Change Bulletin

No: CB014

Description: Addition of Flow Control Valve

Figure 1 – Addition of flow control valves (Item 8)

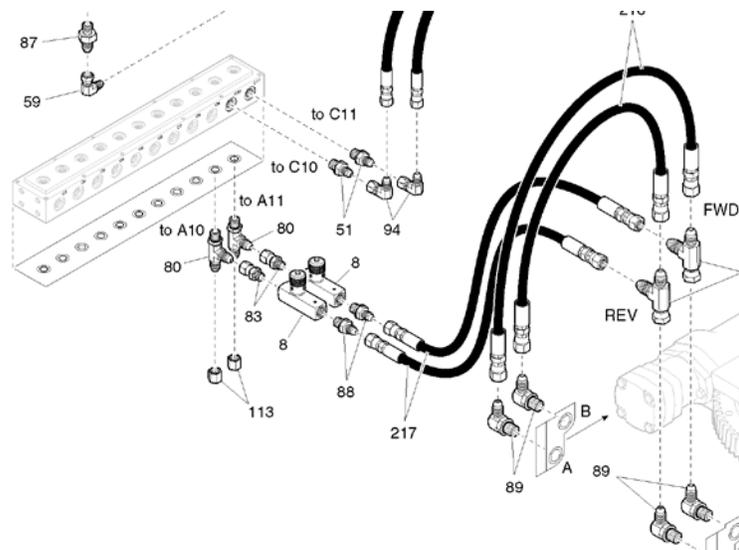
On the 250 TON EMI 400 top drives that incorporate a pressure switch manifold, a condition was identified where both the Forward and Reverse Pipe Handler pressure switches would actuate due to a command in either direction. An investigation indicated that excessive back pressure in the return line was causing the false indication in the return line. To address this issue, flow control valves have been added to reduce the hydraulic flow rate on the pipe handler and eliminate the faulty indication.

- 0022 Valve, Control, 1/4" NPT, c/w Rev Flow Free Check (Item 8 in Figure 1)
- 0214 Fitting, Hyd, Str, #4MNPTx#6FJIC (Item 83 in Figure 1)
- 0289 Fitting, Hyd, Str, #6MJICx#4MNPT (Item 88 in Figure 1)

The addition of the flow control valves in a non-essential upgrade that may be added to the top drive when a unit is brought into a TESCO Service Centre for routine maintenance. This addition may also be done in the field by updating to match revision 6 or greater of part # 730800 (Kit, Aux Hydraulic, EMI 400, w/PC Pump, Pressure Switch), which includes the addition of the following parts to the unit:
